**Master Plan Amendment
MPC File No. 26-002792-ZA
June 23, 2026
MPC Staff Report**

East Broad Market Lofts PD

Address: 601 east 39th Street

Parking allocation for the subject retail property and adjacent apartments

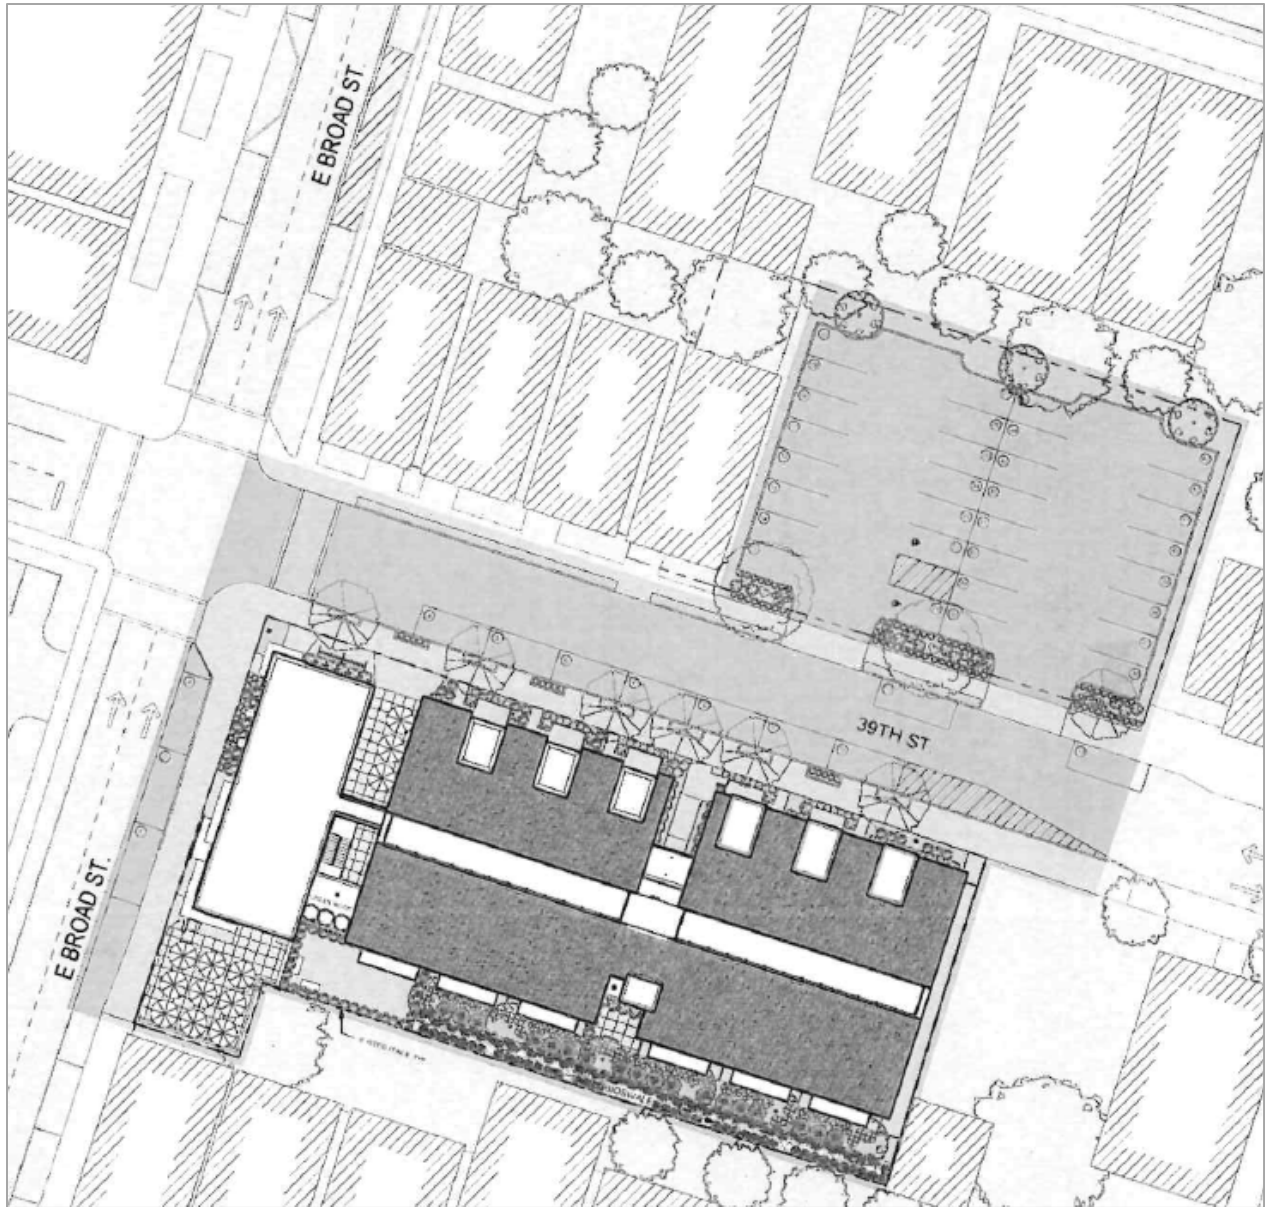
The East Broad Market Lofts PUD established specific parking standards for residential and non-residential uses, including a requirement of one parking space for every six restaurant seats. The requested amendment would reduce this requirement by 50 percent, from ten spaces to five spaces.

While restaurant uses are permitted within the Mixed Use-2 area of the PUD, the applicant has not provided sufficient evidence to demonstrate that the proposed reduction in parking would adequately serve the use. No parking demand study, shared parking analysis, or inventory of available parking has been submitted to support the request or demonstrate that the parking demand generated by the proposed restaurant can be accommodated without affecting surrounding parking resources.

MPC Staff recommends **denial** of the requested amendment to reduce the required off-street parking from ten (10) spaces to five (5) spaces. While restaurant uses are permitted within the Mixed Use-2 area of the East Broad Market Lofts PUD, the applicant has not demonstrated that the proposed reduction in parking will adequately accommodate the parking demand generated by the use.
